ITS CORPORATION				REV	ECN	DATE	APV
THIS PRINT IS THE PROPERTY OF ITS CORP. IT SHALL NOT BE COPIED WITHOUT PERMISSION.				TITLE			
				SCH. BIAS PROTECTION BD. 4 SECTION (1500-3114)			
REV	ECN	DATE	APV	DWN			
FINISH	CHK	CAR	5/24/93	DWG. NO.			
---	REL	CAR	5/24/93	1500-3114			
				SCALE	---	SHEET	1 OF 1

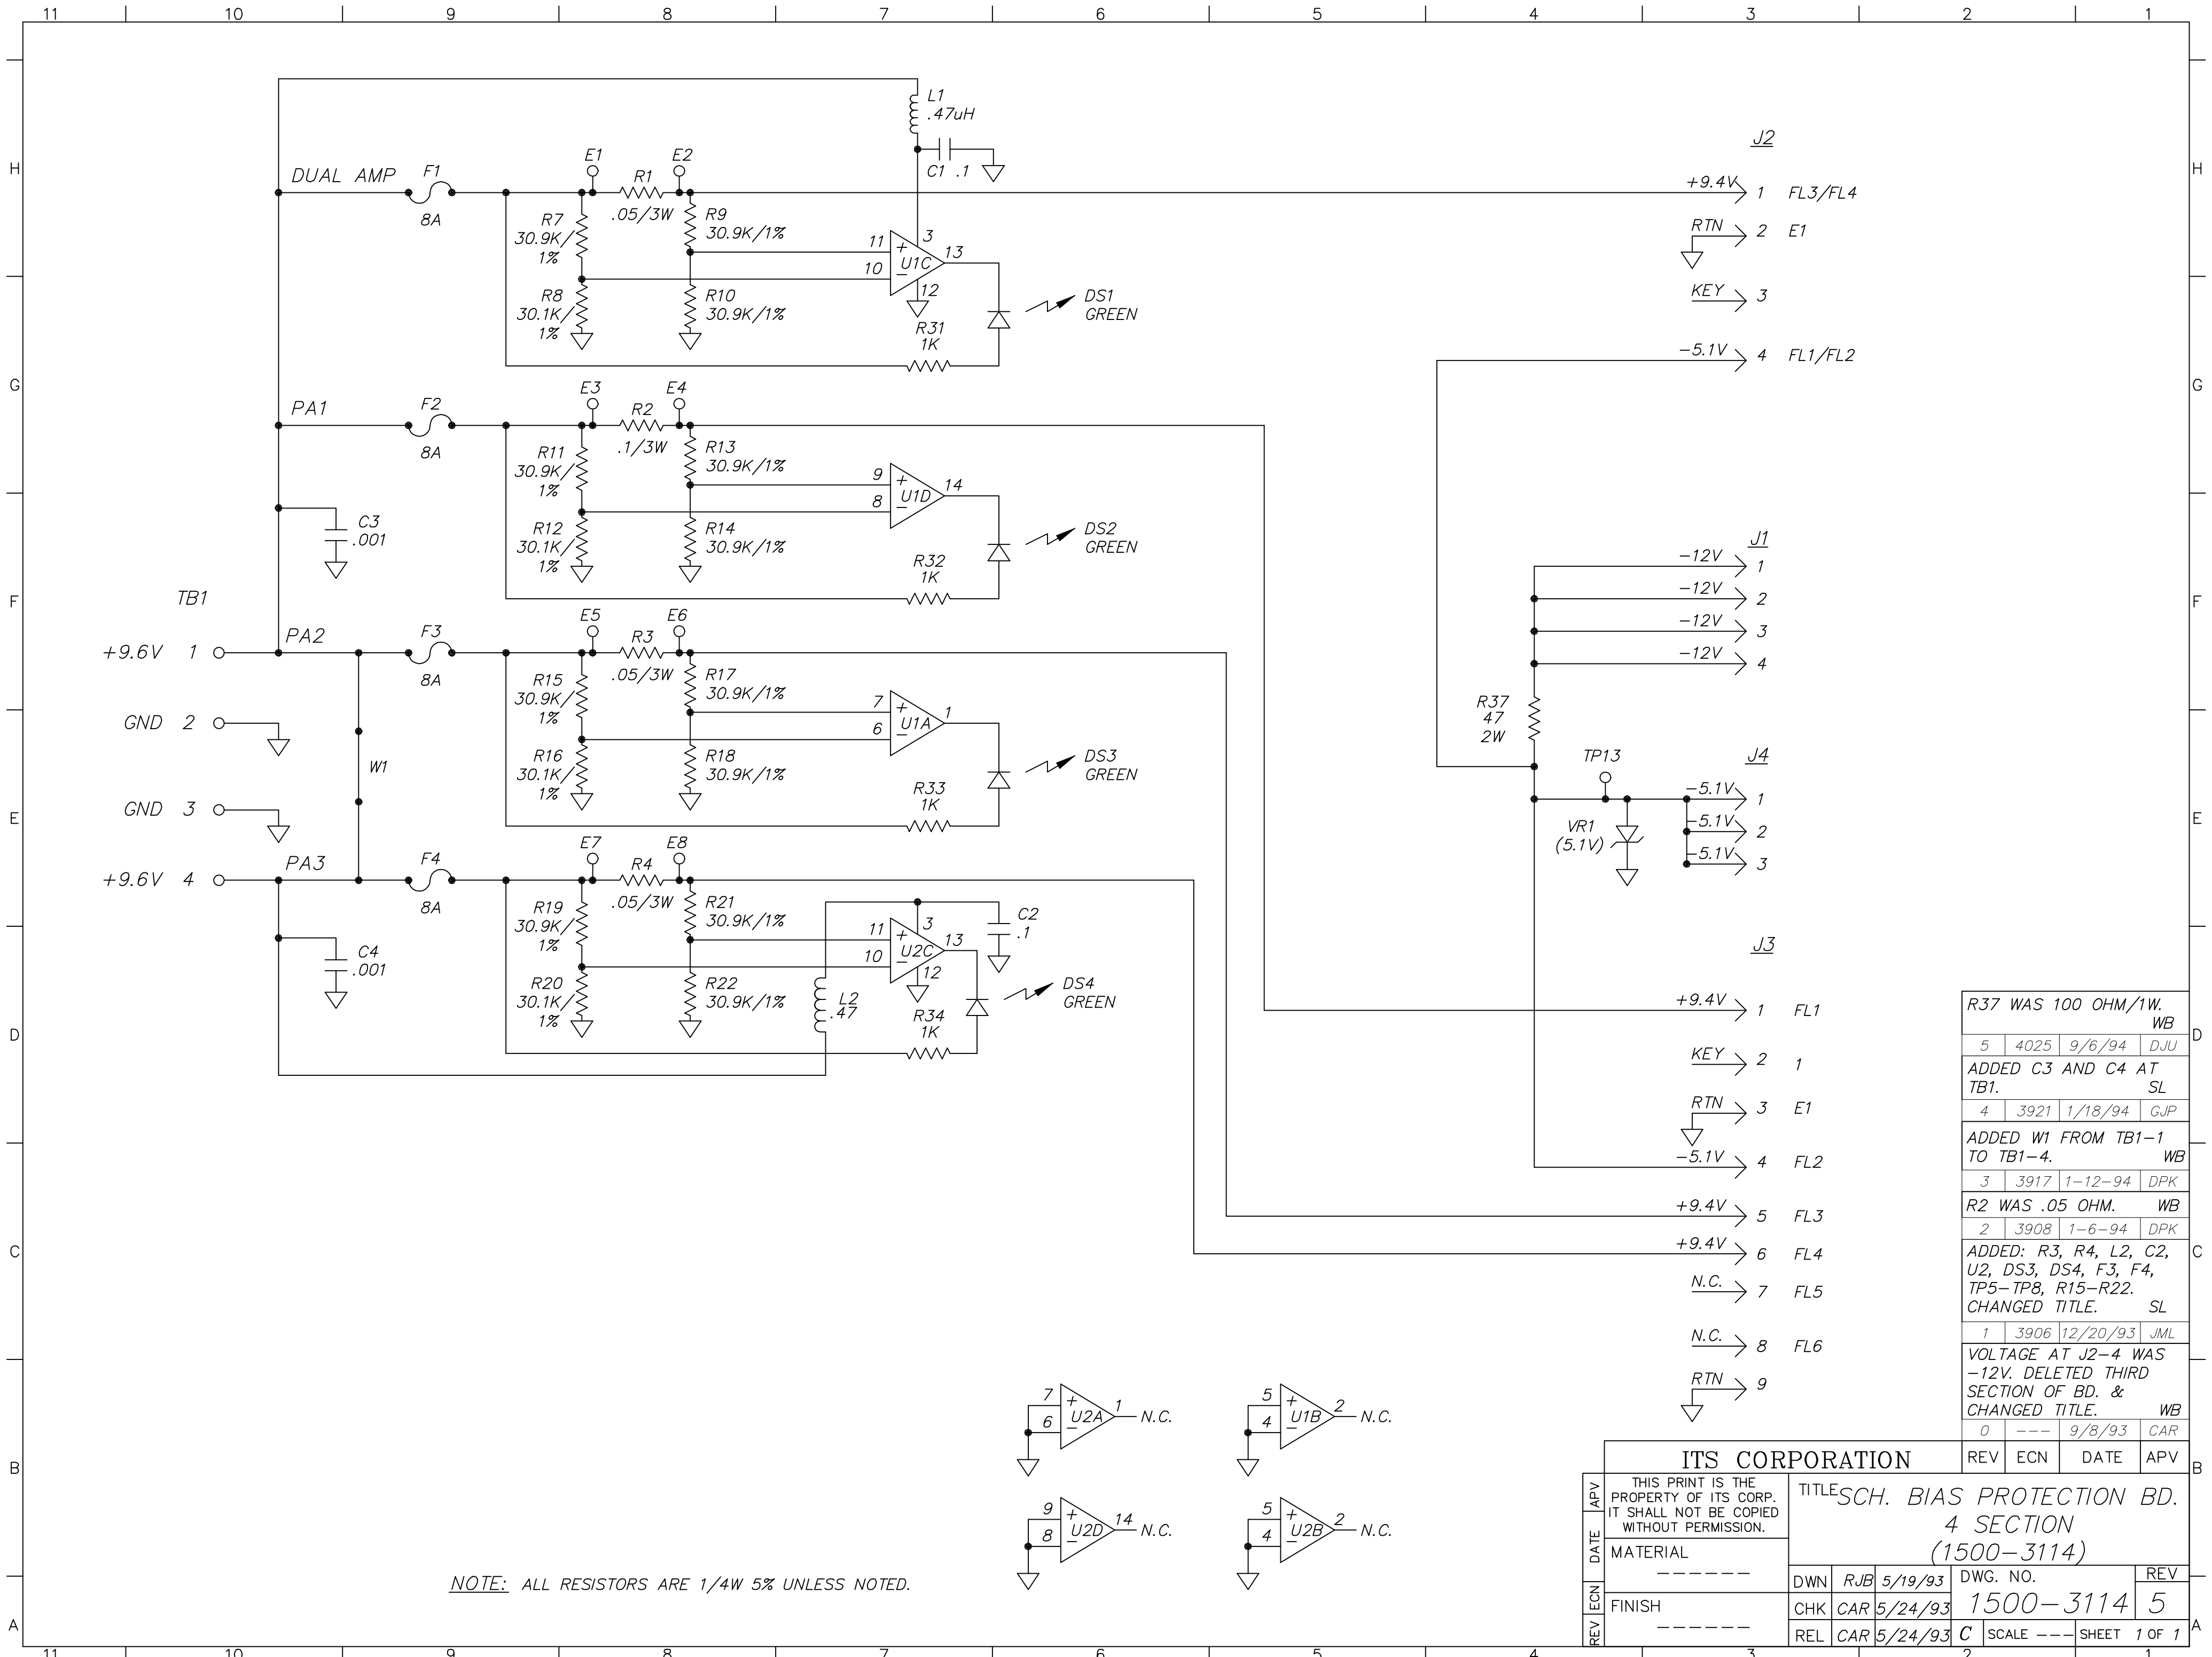
R37 WAS 100 OHM/1W.				WB
5	4025	9/6/94	DJU	
ADDED C3 AND C4 AT TB1.				SL
4	3921	1/18/94	GJP	
ADDED W1 FROM TB1-1 TO TB1-4.				WB
3	3917	1-12-94	DPK	
R2 WAS .05 OHM.				WB
2	3908	1-6-94	DPK	
ADDED: R3, R4, L2, C2, U2, DS3, DS4, F3, F4, TP5-TP8, R15-R22.				SL
CHANGED TITLE.				SL
1	3906	12/20/93	JML	
VOLTAGE AT J2-4 WAS -12V. DELETED THIRD SECTION OF BD. & CHANGED TITLE.				WB
0	---	9/8/93	CAR
